Highway Bill Reid

Middletown Springs
TH 6 North Street

APPROVAL
WATERSHED MANAGEMENT DIVISION
DATE 6-8-2015 (as amended) 4
BY Josh Carvajal
THIS APPROVAL IS SUBJECT TO THE TERMS AND CONDITIONS OF STREAM ALTERATION PERMIT # 54-07-007 - ISSUED HEREWITH 2015

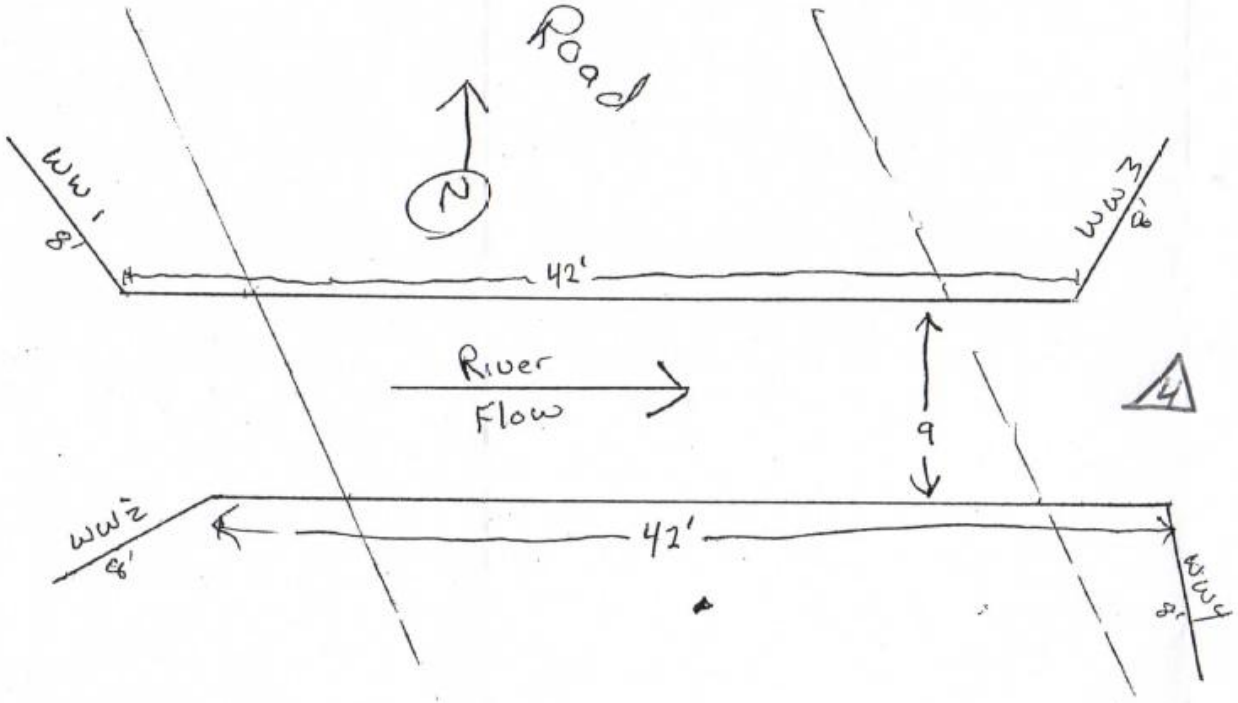
2 - infill material = native stone > 24" with 25% gravel (< 2")
supplement with Type II (36" minus) rip rap
ANR Type E1 = 18" max w/ 50% > 12" smallest

#5 - Temp road culvert to be 24" pipe

4 - fill in scour pool w/ Type II stone

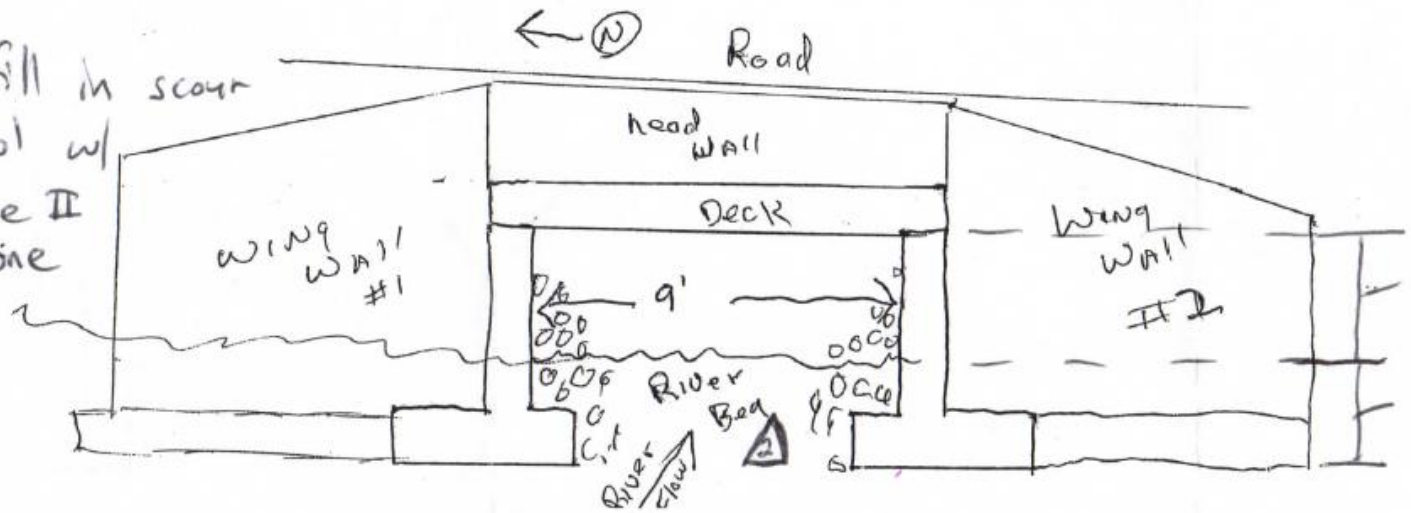
Type E1 OK
